Contract Program: **Technical Support for the Reactor Systems Branch (L1697/P2)**

Subject of Document: **Review of Vermont Yankee Implementation of Solution I-D: Use of LAPUR-5 for Exclusion Region Calculations.**

Type of Document: **Technical Evaluation Report**

Date of Document: **July, 1996**

Figure 1. Summary of Yankee Atomic's LAPUR-5 calculations showing that the LAPUR-5 decay ratio error is within ± 0.2

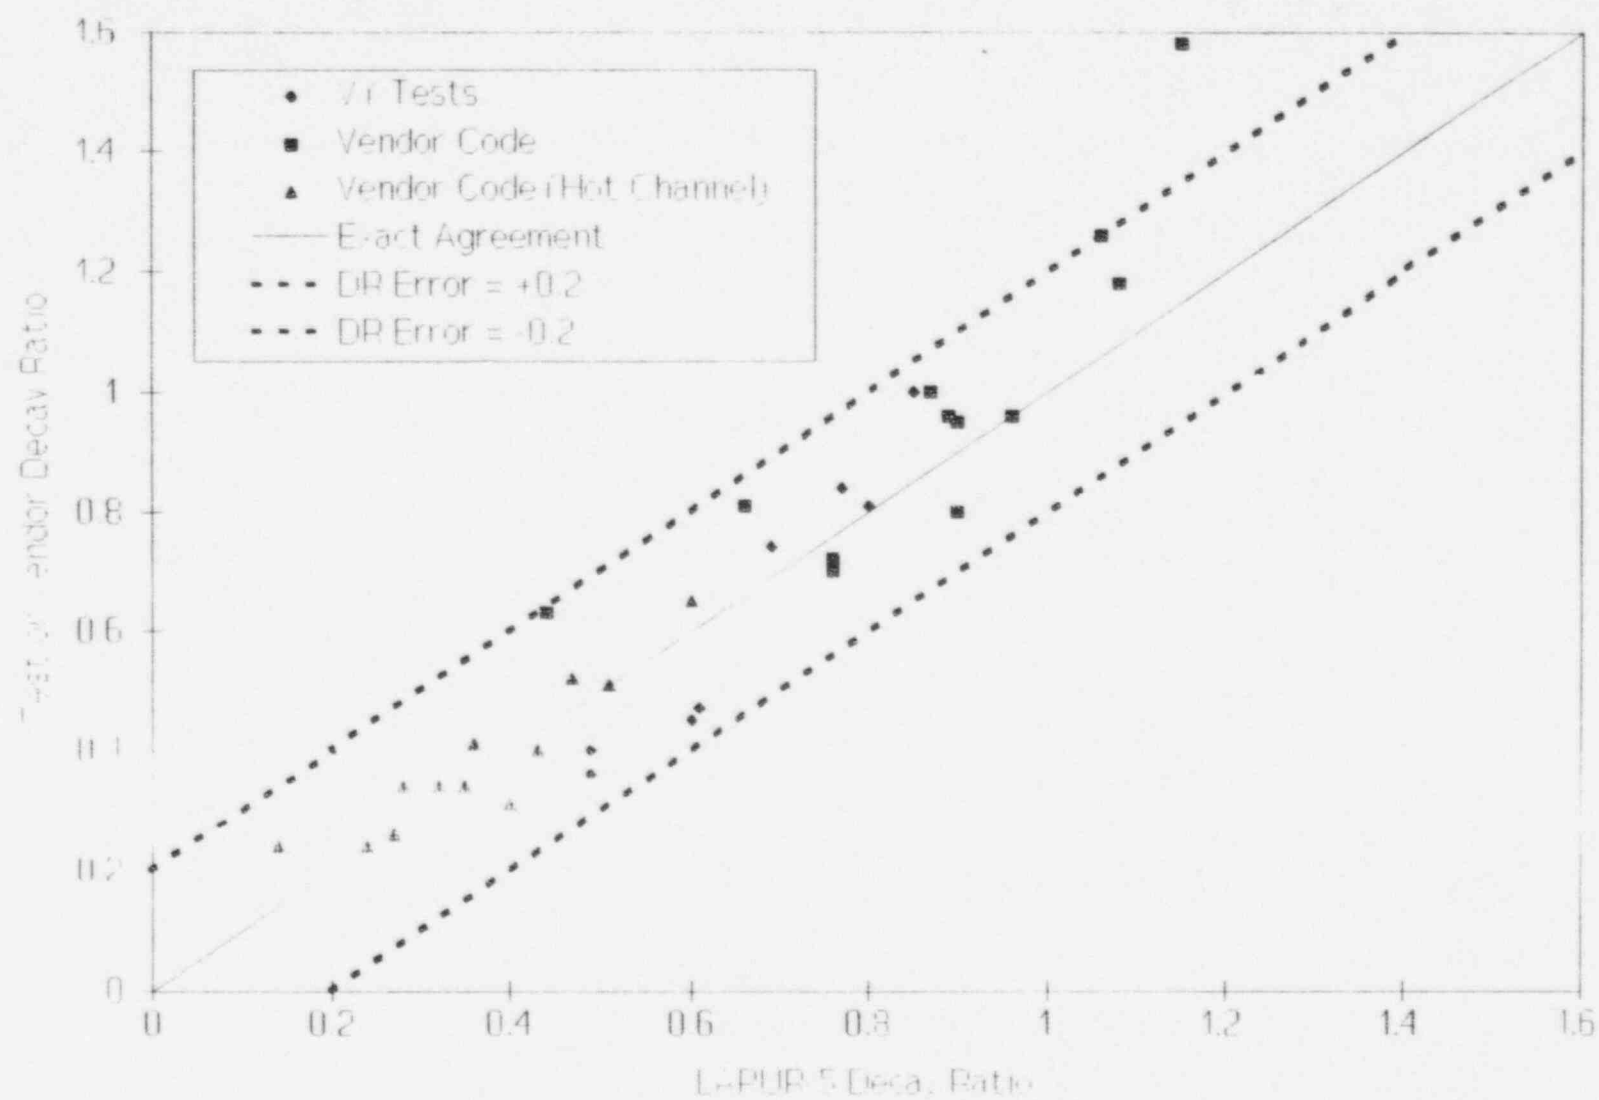
topical report YAEC-1926¹ contains a number of benchmarks against the Vermont Yankee 1981 stability tests, and comparisons against other calculations using a vendor code. We have summarized these calculations in Figure 1, which compares the decay ratios calculated by Yankee Atomic versus the 1981 stability tests, and the vendor-calculated values for both core and hot channel. The results in this figure indicate that Yankee Atomic understands the LAPUR-5 input preparation process and can reproduce the results from tests and vendor calculations.

- (2) Based on the benchmark data presented in YAEC-1926,¹ we conclude that the accuracy of Yankee Atomic's implementation of the LAPUR-5 code results in a decay ratio error of ± 0.2 . With this accuracy, decay ratios estimated using Yankee Atomic's LAPUR-5 implementation can use the standard BWROG acceptance region in the core versus hot-channel decay ratio map^{3,4} where the core and hot-channel decay ratio boundaries are set at 0.8.
